**MODIFICATION REQUEST:
Site 4B, Sydney Olympic Park
(MP06_0273 MOD 4)**

Director-General's
Environmental Assessment Report
Section 75W of the
Environmental Planning and Assessment Act 1979

April 2013

Figure 3: Northern Building Ground Floor

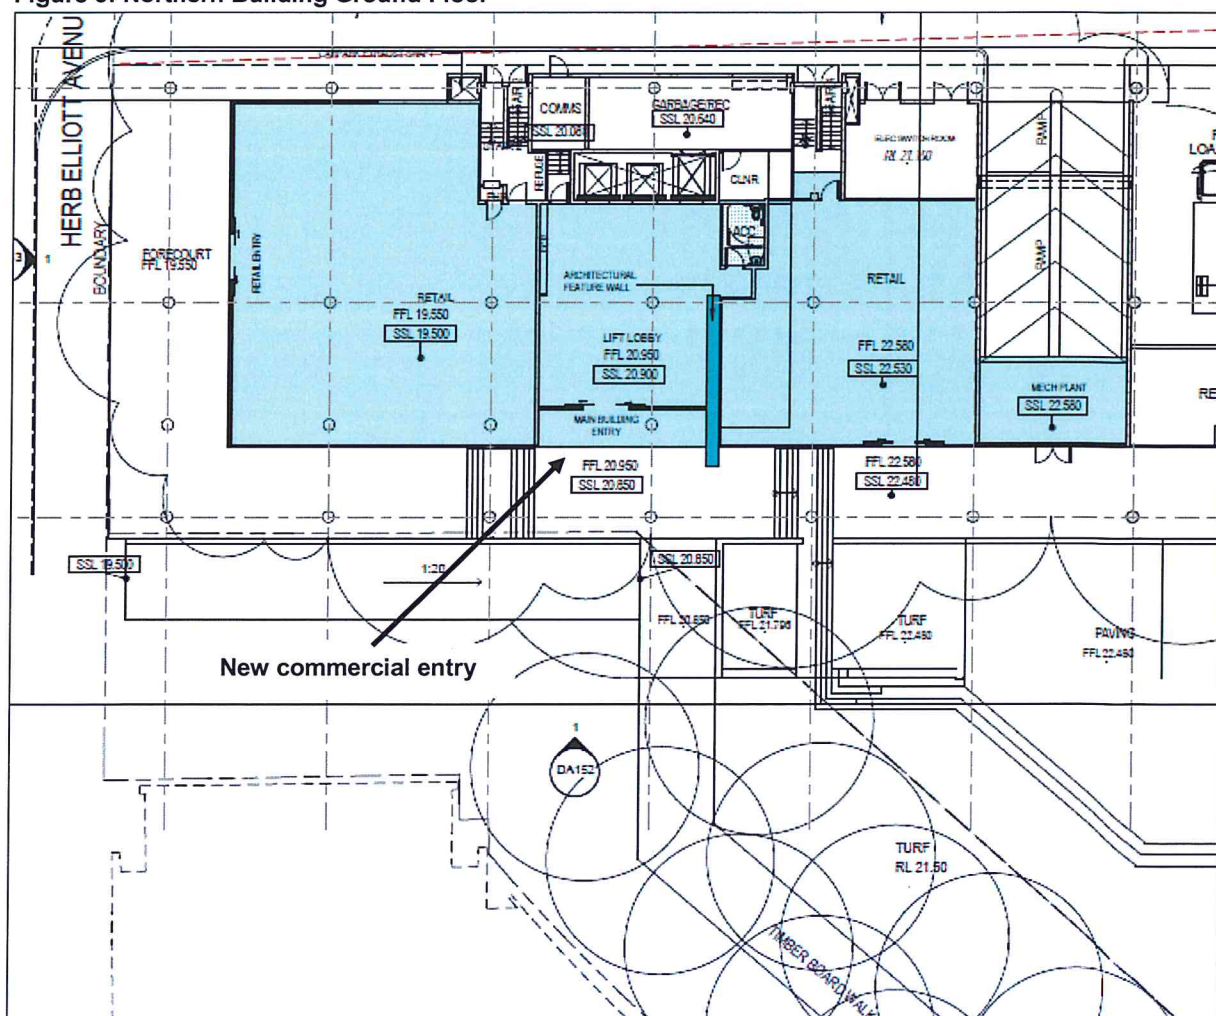
The proposed modification to the layout and FFL's of the ground floor of the northern building will not significantly change the appearance of the building from Herb Elliot Avenue or the future north-south road. The proposed amendments are considered to provide more functional retail tenancy footprints and improve their relationship with the public domain through the provision of a level transition between the different spaces.

The proposed relocation of the northern building commercial entry lobby from Herb Elliot Avenue to the proposed central location adjacent to the internal public domain area (see Figure 3), in conjunction with the retail tenancies, will assist in providing and promoting good surveillance for pedestrians and users of the space. The proposed recessed treatment of the lobby's façade and protruding architectural feature wall will ensure that the space is better defined as a separate function to the adjacent retail tenancies.

The proposed floor layout and FFL amendments to the northern building retail tenancies and commercial entry lobby would provide limited access for disabled persons, particularly due to the staged construction of the northern and southern buildings (and associated public domain).

SOPA commented on the proposed amendments, advising that the revised floor levels would fail to comply with the requirements of the DDA and SOPA's Accessibility Guidelines, particularly the access provided between the lobby, southern most retail tenancy and the public domain.

In response the proponent has provided a statement from an access consultant, inclusive of indicative sketches detailing access options during construction and operation, concluding that compliant access can be provided for each stage of development.

Compliance with these standards would require the temporary installation of a wheelchair platform lift to provide access between the northern building lobby and southern most retail tenancy during construction of the southern building and require minor design amendments to the public domain to accommodate an additional access ramp. The resultant impacts to the public domain are not considered detrimental to its design or functionality, and SOPA have also advised that these changes to accommodate improved access are supported. Furthermore, condition B14 also requires the proponent to submit a final landscape and public domain plan for final approval prior to the release of the construction certificate for the public domain.

The department considers the measures proposed to be acceptable and will ensure that suitable access is provided during all stages of construction. In accordance with the access consultant's recommendations, a new condition will be included requiring the preparation of an operational management plan to facilitate the use of the wheelchair platform lift during the time of its installation.

Figure 4: Eastern Elevation

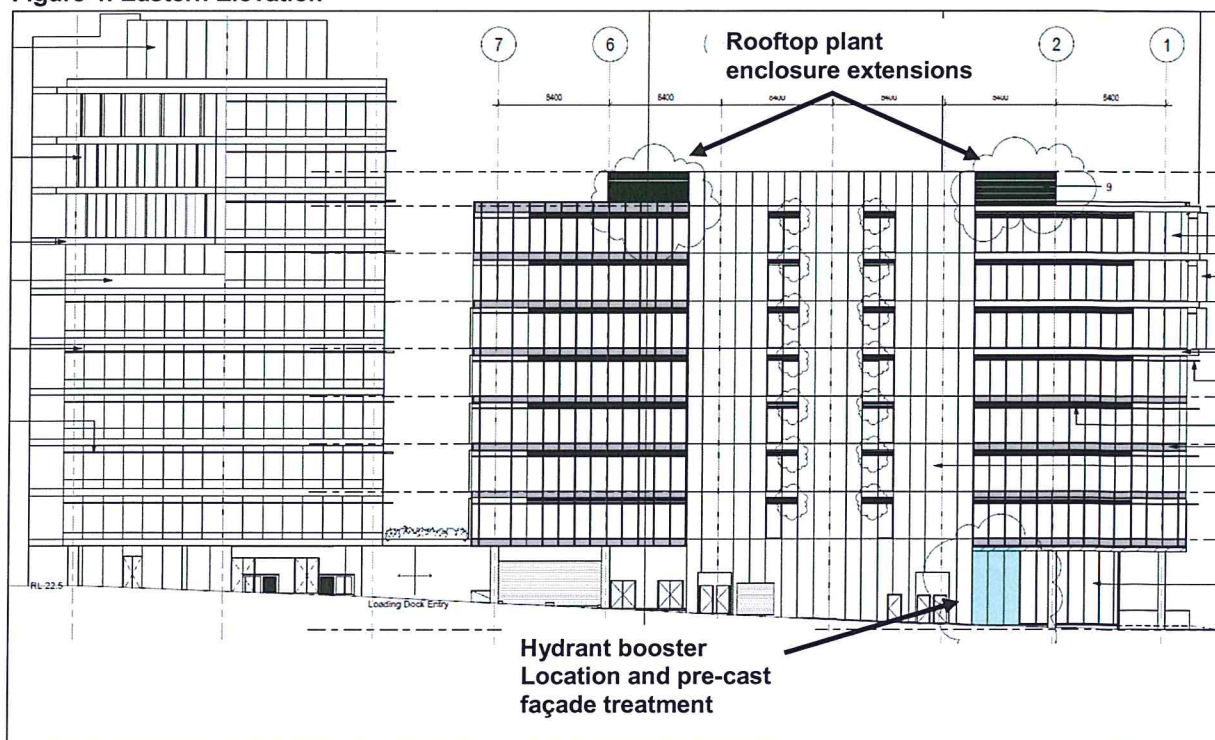
The proposed installation of the hydrant booster and associated pre-cast concrete façade material change will not have a detrimental impact on the design and character of the northern building (see Figure 4). Similarly, the proposed introduction of louvres to the basement vehicle ramp will provide a façade treatment to suitably screen the service area and proposed new plant platform.

The built form of the proposed expanded rooftop plant enclosure will become more visible along the eastern elevation of the northern building. Notwithstanding, the expansions north and south of the building core, proposed to be screened using powder coated aluminium louvres, will not significantly change the appearance and character of the approved building design.

It is noted that the rooftop plant enclosure approved under MOD 1 was approximately 45 m in length, 5 m in height and setback approximately 5 m from the eastern elevation. MOD 3 had previously reduced the plant enclosure's height from 5 m to 2.6 m and reduced its length to approximately 34 m. In this respect, the increased roof coverage is not significant to that which was approved under MOD 3 and still of less impact than that previously approved under MOD 1.

The department considers the proposed changes to the internal layout, FFL's, external façade treatments and rooftop plant enclosure to be minor and will not impact on the building's appearance within the SOP setting.

Figure 5: Basement Level 2

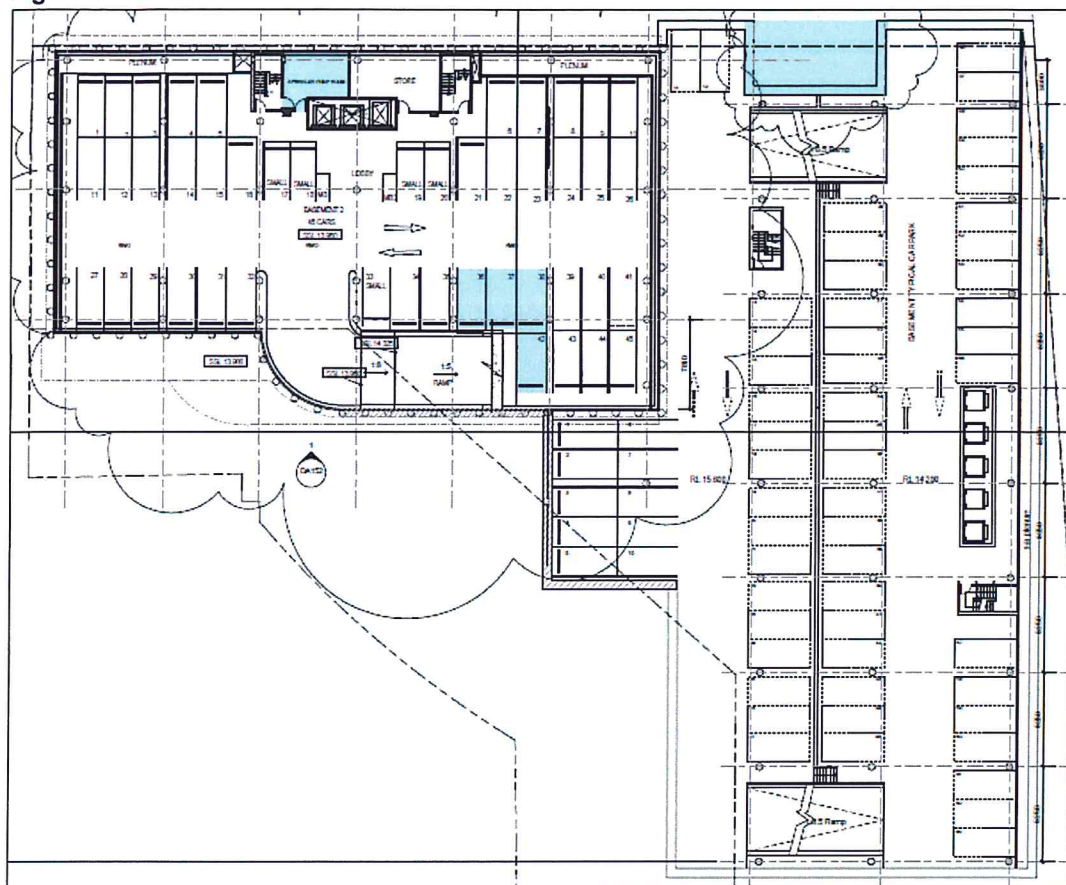
The proposed modifications (coloured blue in Figures 5 and 6), increase the total number of parking spaces to 274 spaces and make minor amendments to the layout and location of accessible spaces. Whilst the total number spaces located within the basement levels of the southern building is proposed to decrease by four due to the location of the proposed new kiosk substation, a compensatory increase within the northern building basement levels will satisfactorily cater for any loss. The department considers the minor amendments to the layout and parking arrangements to be satisfactory.
